TOWN OF COVENTRY, RI
DEPARTMENT OF PLANNING & DEVELOPMENT

STAFF REPORT

Project Name:	Janelle Art Studio
Plan Type:	Minor Land Development with Associated Dimensional Variances
Plan Review Phase:	Preliminary Plan Stage
Owner/Applicant:	Michael Janelle
Address:	420 Washington St.
Plat / Lot / Zone:	AP 56 Lot 77 Zone VMC Lot Size 6,221 Sq. Ft.
Existing Use:	Vacant Lot
Proposed Use:	Personal Art Studio
Description:	The applicant proposes to construct a small art studio on a currently vacant 6,221 SF lot. The applicant is seeking zoning variances from the minimum required landscape buffer, minimum number of required loading spaces for a commercial building, the minimum distance between a curb cut and intersection, the minimum distance between the subject curb cut and the closest abutting curb cut, and relief from providing the engineering report to accompany the above curb cut request.

TECHNICAL REVIEW COMMITTEE REPORT

Proposed Conditions

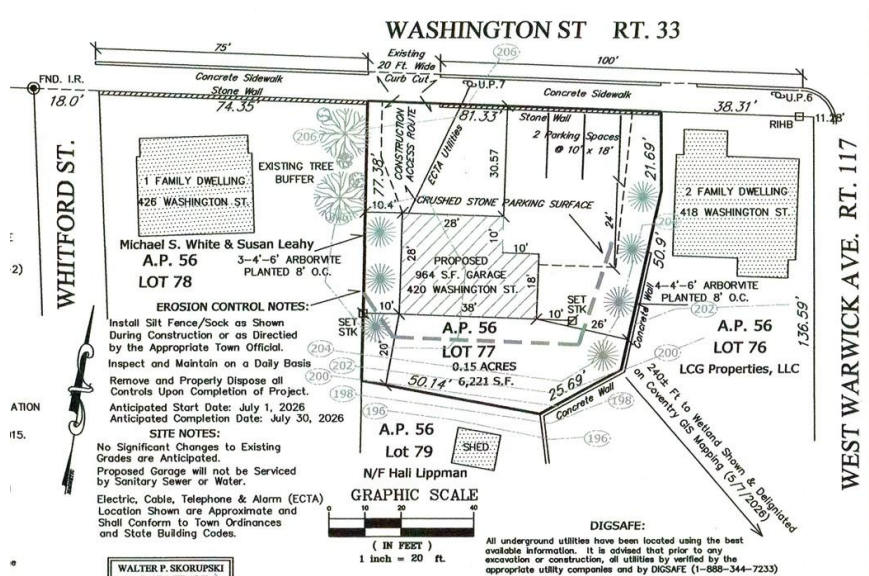
- Applicant is seeking a dimensional variance for the 50' minimum required landscape buffer. Applicant is proposing plantings on either side of the building to mitigate neighborhood impacts and demonstrate the semblance of a buffer.
- Applicant is seeking a dimensional variance for the minimum number of required loading spaces (1) for this commercial structure. Applicant has clearly noted that there will be no industrial

deliveries to this property, and that his structure is not large enough to accommodate a loading space.

- Applicant is seeking a dimensional variance for the minimum distance between a curb cut and intersection, and relief from providing the engineering report to accompany the above curb cut request. Code requires commercial properties be 150' from the closest intersection, where this property is 75 feet from the closest intersection (Washington St. & Whitford St. intersection).

- Applicant is seeking a dimensional variance for the minimum distance between the subject parcel's curb cut and the closest abutting curb cut. Code requires commercial properties be 150' from the closest curb cut, where this property is 85 feet from the closest curb cut.

- Staff note that the parking requirements for this commercial structure are satisfied by the two (2) parking spaces noted on the plan.
- Applicant has noted that he will be the sole inhabitant of the space. This art studio will *not* be open to the public, and will serve as a "hobby shop" art studio for the applicant. With this, the applicant has noted a low volume of traffic, likely not generating an increase.

1. The application is void of water and sewer connections to the building
2. The building does not meet the minimum size lot if the applicant intends to convert the proposed Art Studio to a dwelling unit.
